NICK3RSON APARTMENTS

609/615/621 W NICKERSON STREET, SEATTLE, WA 98119 | PROJECT #3026191
2nd DESIGN REVIEW RECOMMENDATION

BOARD GUIDANCE: ARCHITECTURAL CONCEPT

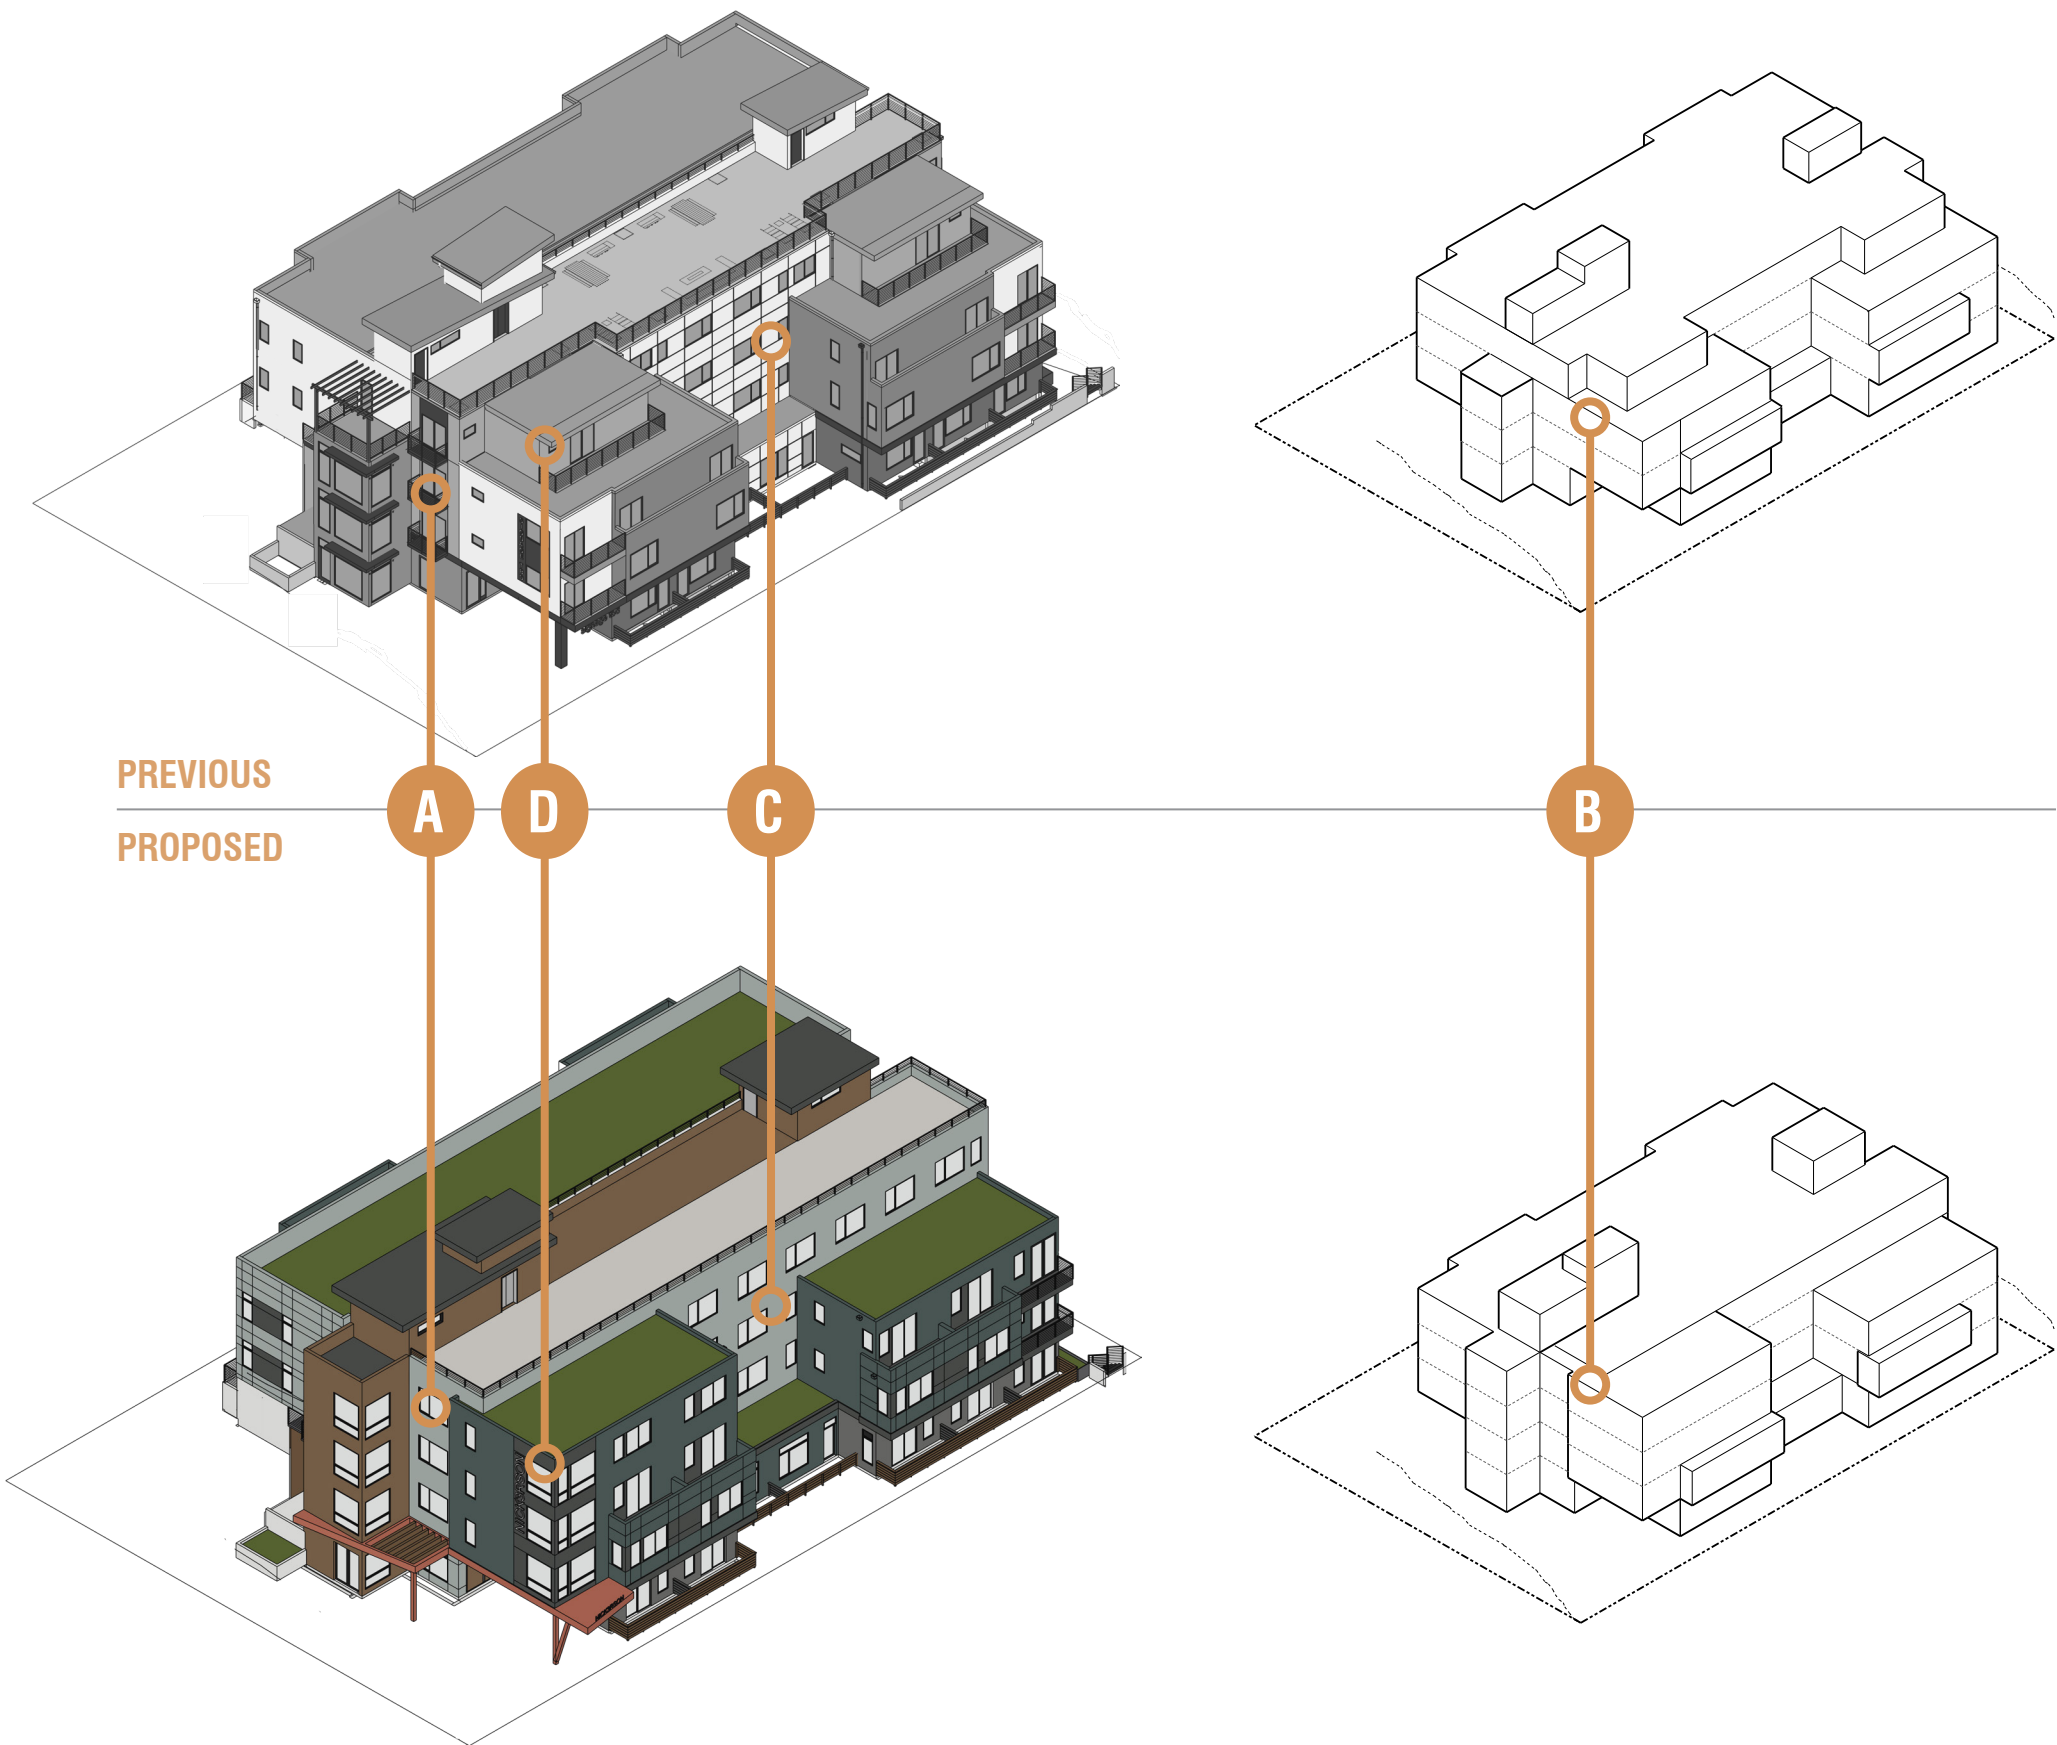
- A** The Board asked that the applicant simplify & clarify the choices of materials, colors, fenestrations, pattern, and detailing to create a legible order and hierarchy that supports a clear architectural concept. The Board agreed that the multiple massing shifts and changes in siding type and color did not yet exhibit a legible compositional order. [DC-2]

- B** The Board asked that the applicant simplify and clarify these choices to create a legible order and hierarchy that supports a clear architectural concept. [DC2-B]

- C** The Board agreed that in this largely symmetrical composition, the deep setback of the white-clad mass in the center of the project works at cross purposes with the intent to locate the principal entry not at the center but at an outboard edge.

- D** The Board asked the applicant to re-order this compositional logic to support the intended entry location. [PL2-D, PL3-A, DC-1, DC2-B]

- The design concept began with an initial slice from west to east through the overall mass to give the illusion of movement on the site reflective of the movement along Nickerson. The slice is punctuated by a beacon element at the eastern edge. This concept has been expanded to include:
- A second slice through the overall mass
 - Materials applied with rigor to reflect the simplified organization of the massing concept.
 - A glimpse to the internal slices by cutting away from the masses – adding the benefit of providing light and air to residents while exposing the inner slices.
 - Upper floor re-ordered to give weight to the location of the entry at the eastern edge, and provide a clearer visual of the exposed slices.
 - The entry and amenity tower beacon have been connected visually and physically with vertical windows and a brise soleil.

BOARD GUIDANCE: MATERIALS

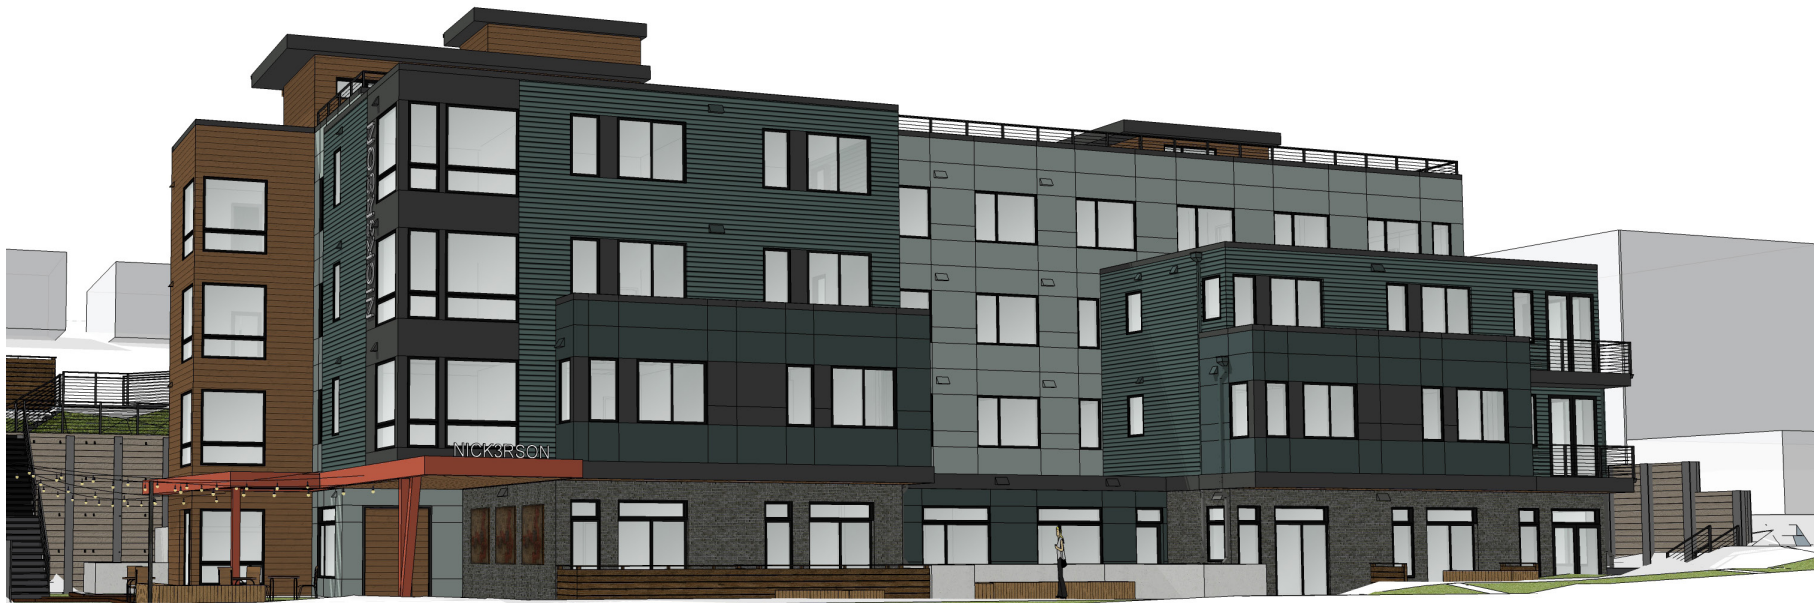
A The Board asked that careful consideration be given to how the “special” materials (brick and wood cladding) are used to make the most of these higher-quality materials. [DC4, DC2-C, DC2-D]

Materials have been simplified and reduced in order to better reflect the massing concept.

- Materials are consistent on each slice of the building, the changes in materials happen to changes in the slices, taking special care that the materials do not feel painted on. This is clearly evident at the exposed slice at the entry and more visible central mass at upper levels.
- Higher quality materials are used at the base, where the brick can be enjoyed by pedestrians and residents alike, and at the community spaces, with the wood cladding at the beacon element signifying its community use and connecting the amenity spaces at the ground and roof levels.
- Per the Board recommendation, the quantity and variety of materials has been reduced and simplified.

BOARD GUIDANCE: ENTRY SEQUENCE

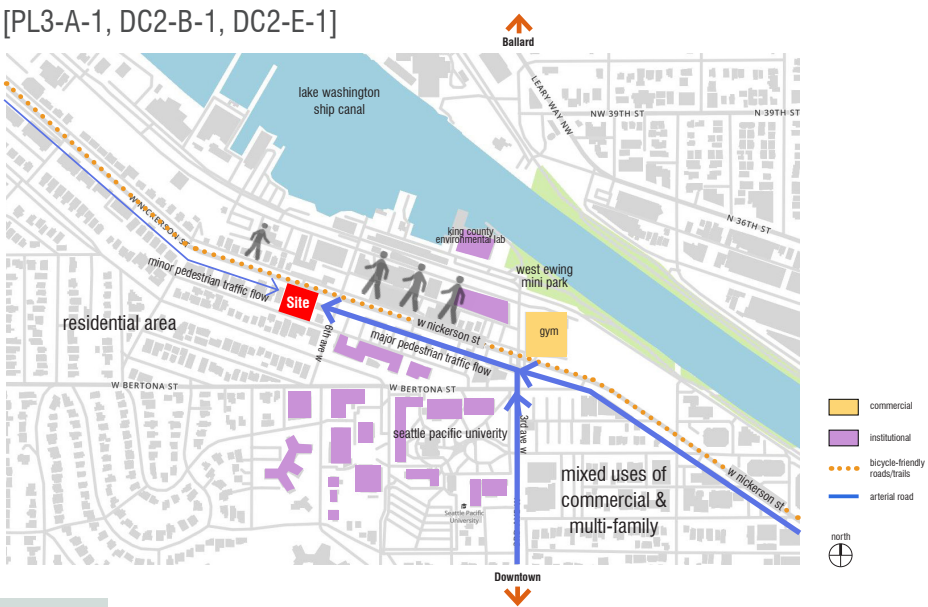
- A** The Board supported the proposed unique entry sequence; a combination of exterior amenity space, through-connection to alley, amenity tower 'beacon' and principal entry.
- B** The board agreed that the elements of this composition should be revised and re-ordered to create a strong entry expression and unique identity for this area, one that clearly indicates its location and primacy. [DC2-E, PL3-A]
- C** The Board supported the idea of the entry tower 'beacon' and asked that this gesture be strengthened to read more clearly, and that its form be better integrated with the larger composition. [PL3-A, DC2-B]

The proposed entry is located at the eastern edge of the building, recessed from the front facade. This location allows the entry and its associated covered walk to directly relate to the adjacent amenity space, allowing inside and outside to blend together.

- An amenity tower (clad in wood siding, which helps to signify its use moving up the building) acts as a beacon adjacent to the entry. This both connects the various levels of entry and amenity space as well as serves as an identifying feature for visitors and residents alike.
- The massing and fenestration has been reordered to add weight to the eastern edge, and similar window styles and the brise soleil provide both a physical connection and logical visual signifier of the entry and amenity beacon

BOARD GUIDANCE: FENESTRATION

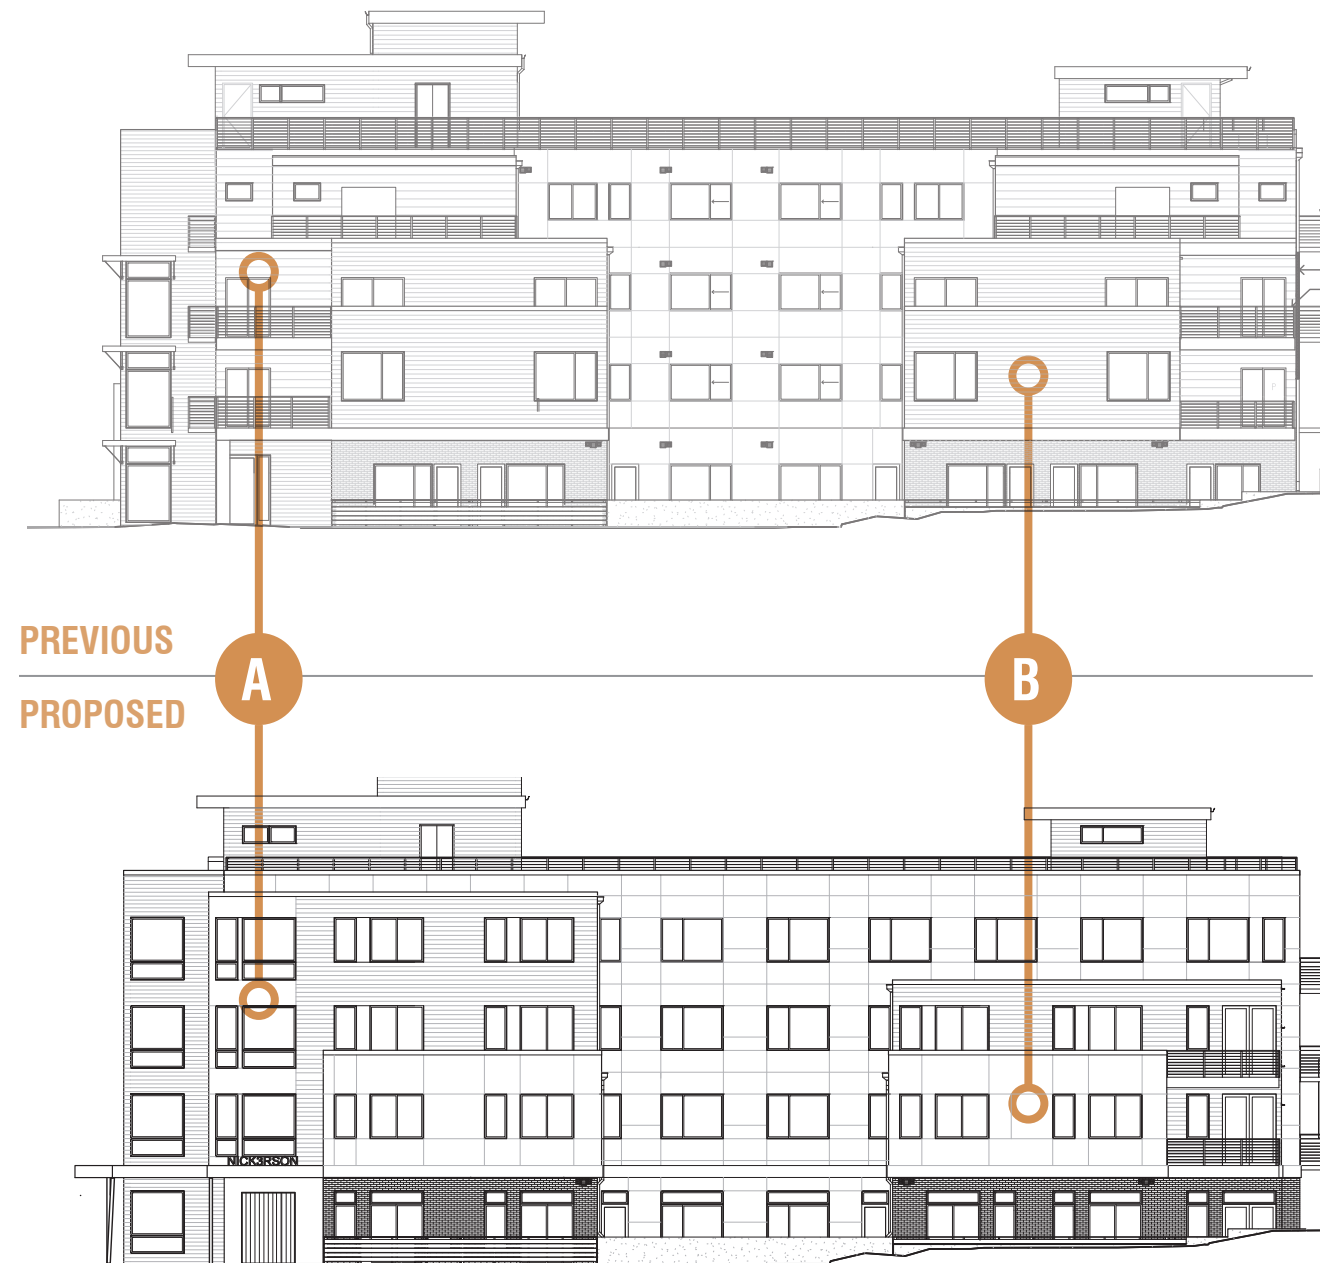
- A** The Board asked the applicant to develop a simplified & legible language of window sizes, types, and uses, and to organize them in a pattern that supports the larger compositional order. [DC2-B, DC2-C]
- B** Where large areas of opaque wall appear on the Nickerson elevation, the Board encouraged the applicant to consider larger windows and/or a reorganization of the elements to create a more harmonious composition. [DC2-B]

Originally, the proposal included a wide variety of window types and sizes. Additionally, the window locations were predominantly located based on their relationship to the interior spaces. Based on the Board's feedback, have reduced the variety of window types and provided a clearer logic to their location.

- Window sizes have been increased, parapet heights reduced, and additional windows added at the Nickerson facade in order to reduce large areas of opaque wall.
- Window and secondary architectural features have been adjusted to better reflect the overall compositional order of the massing.
- A clearer uniformity of window styles has been provided throughout the building, with unique window styles located in order to reflect their importance at the entry corner and amenity tower beacon.

BOARD GUIDANCE: LANDSCAPING

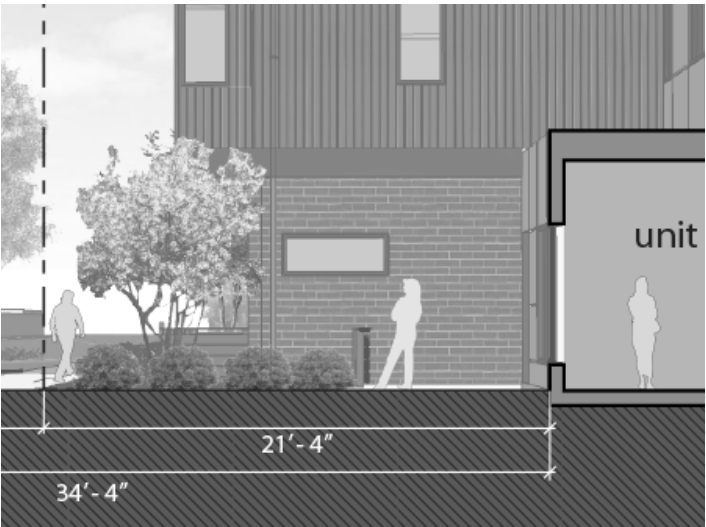
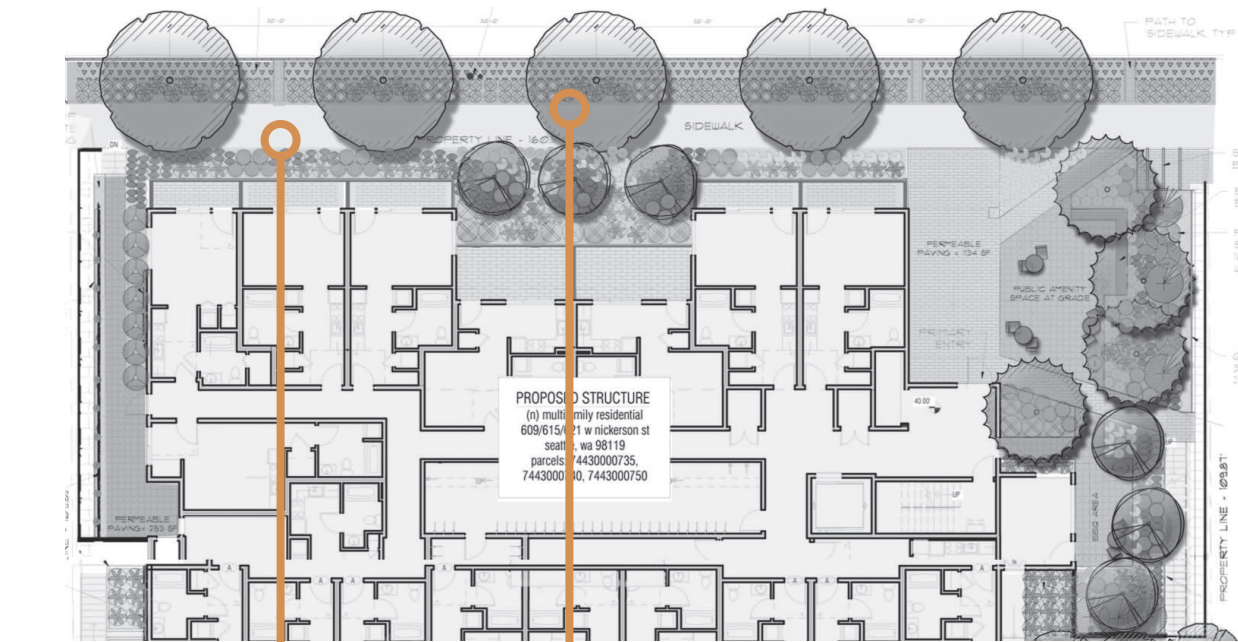
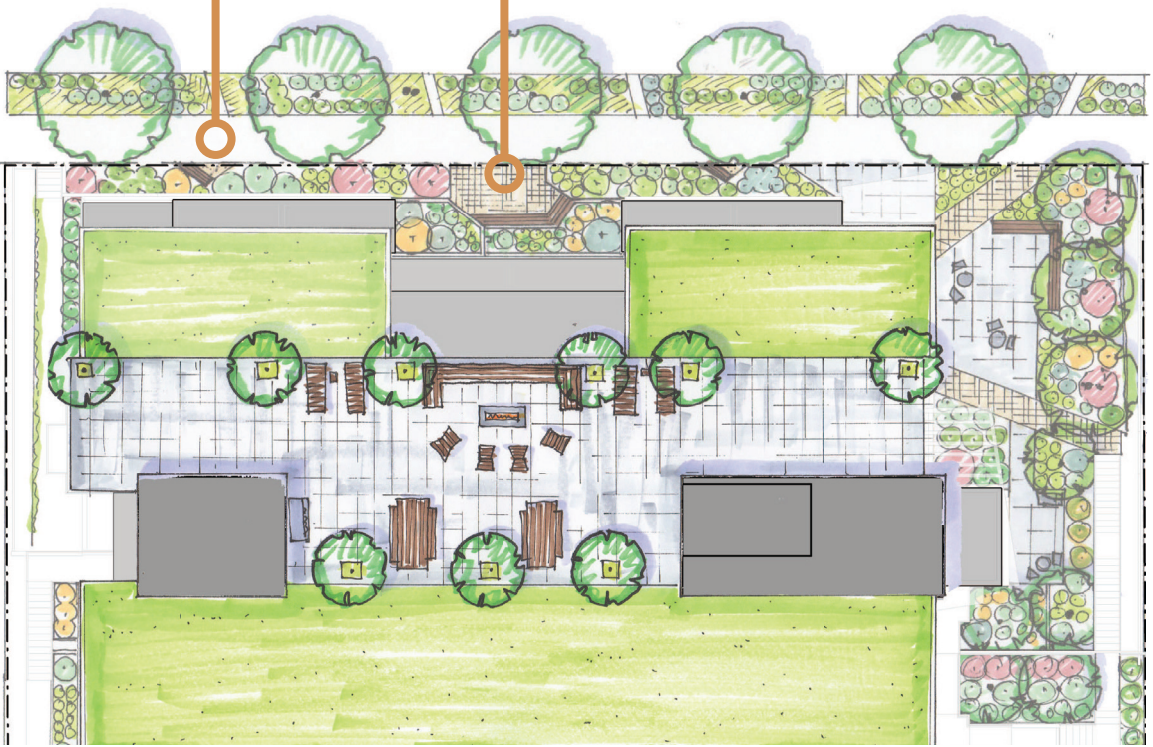
- A** The Board acknowledged the evolution and development of the landscape design at the eastern portion of the site (where the amenity space and entry are located) and asked that a similar level of attention and development be applied to the rest of the street-facing and street-adjacent areas on Nickerson. [PL3-B, DC4-D]
- B** That development should establish a rhythm and pattern of elements (planting-type areas, leaning or sitting spots, ‘eddie’ for pedestrians, etc.) with an understandable order in support of the architectural concept. [PL3]

During the EDG meeting, the Board requested that the building provide a defensible landscape buffer between the sidewalk edge and the private yards. However, during the 1st Design Rec meeting, the Board suggested that the landscape had become too defensible and relentless, and requested more pedestrian engagement and connection to establish a rhythm & pattern of elements in support of the architectural concept.

The landscape has been revised to incorporate public benches, a small eddy, and provide a variety of scales and types of plantings to create visual interest and engagement along the route to the entry. The planting patterns slip towards the entry, reinforcing both the entry location and the overall architectural concept.

The center units at the lower level have been pushed forward closer to the sidewalk, minimizing the feeling of a recessed formal courtyard. The bench at this location gestures towards the entry, emphasizing the entry as the destination, whereas the bench is a part of the journey.

Additional subtle landscape cues have been integrated along the W Nickerson facade to further enforce the gesture.
